Work Order ID 105218

Item Name: Crosstube Turning Detail

| DRAWING NO. D212-664-241 | TITLE CROSSTUBE ASSY (205/212 HI AFT) | REV. D | DART AEROSPACE LTD ENGINEERING ORDER | | D.E.O. NO. D212-664-241-D-1 | SHEET NO. SHEET 1 OF 2 | SCALE NTS |

ADD AN INSPECTION WINDOW TO UNDERSIDE OF CROSSTUBE.

**D212-664-241/-241B
ASSEMBLY DETAIL**

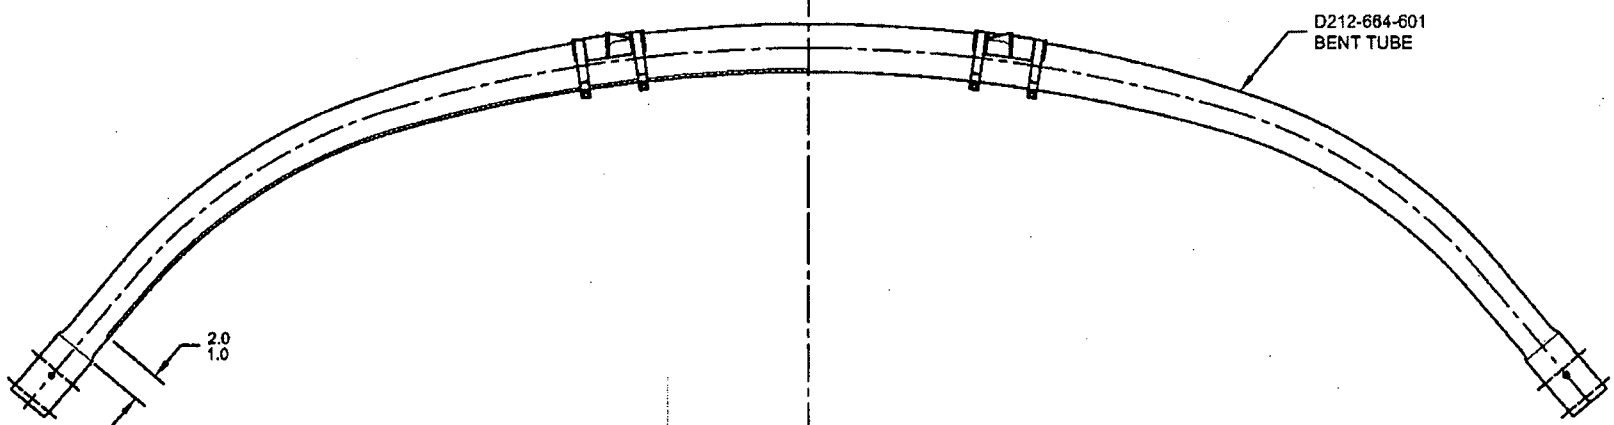
IS:

WAS:

MASK AREA PRIOR TO PAINTING,
REMOVE MASKING AFTER PAINT
AND APPLY CLEAR COAT
